Paul Unbehagen
Big Switch Networks

Scott Fincher
Extreme Networks

802.1Qcj D1.1 Status

Draft AAD State Machine

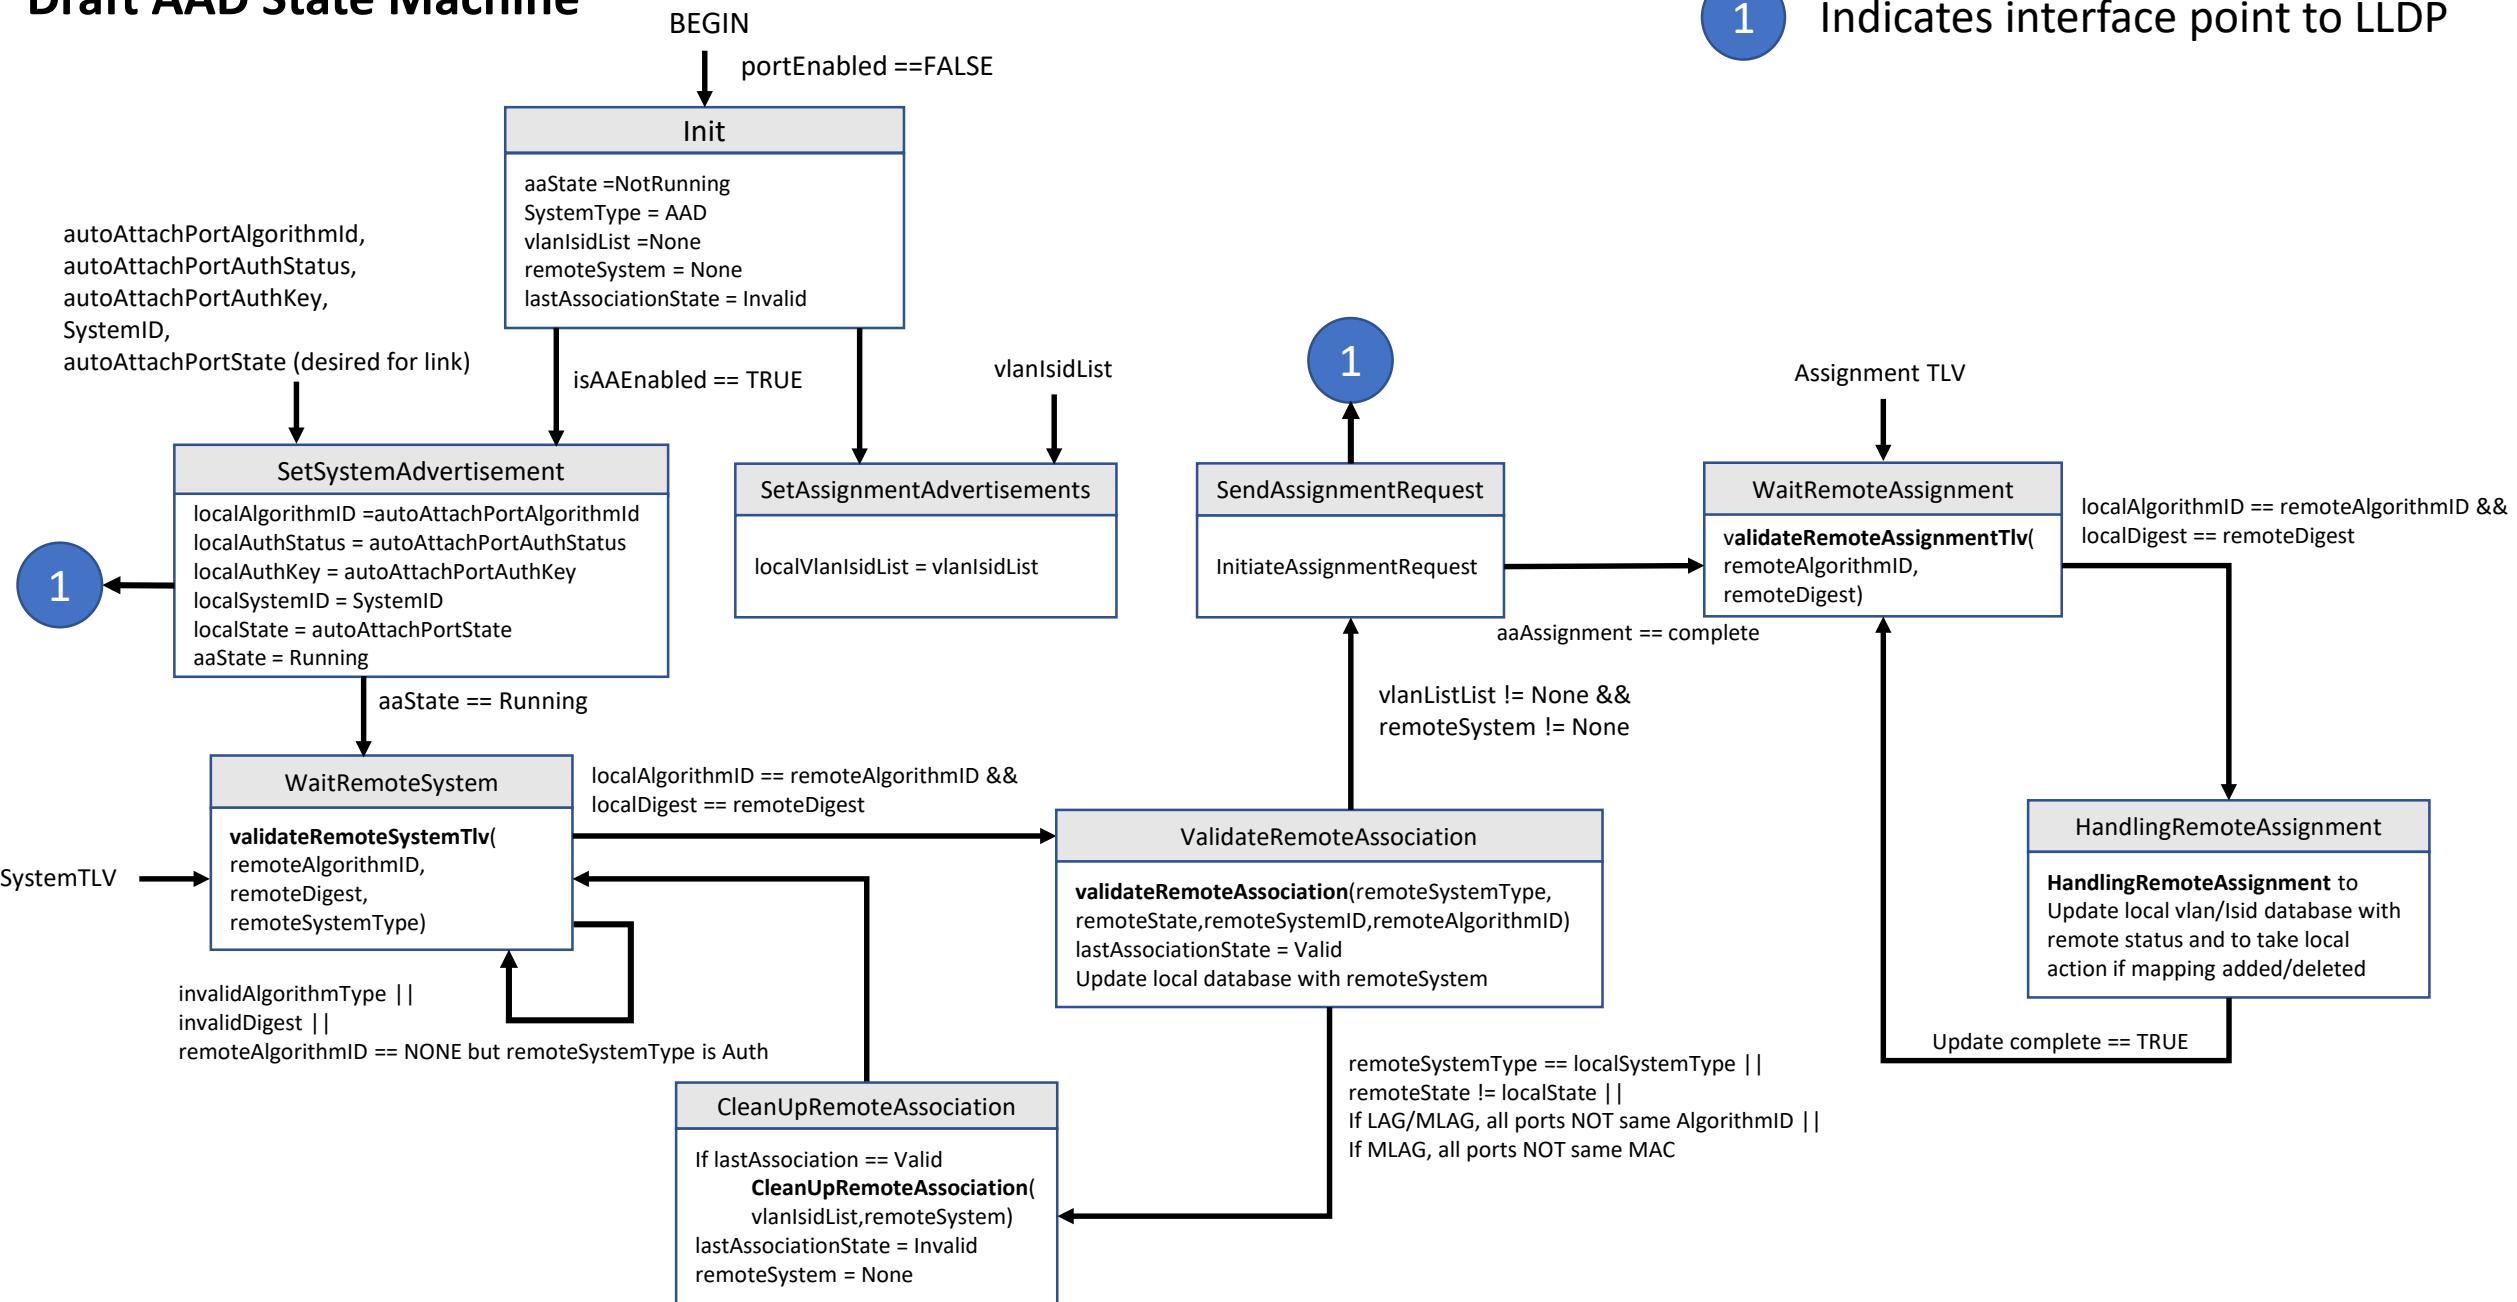
State Machine

- Redesign prepared for next draft.
- AA State Machine should follow LLDP diagrams as implementers will see AA as a side function using LLDP TLVs.
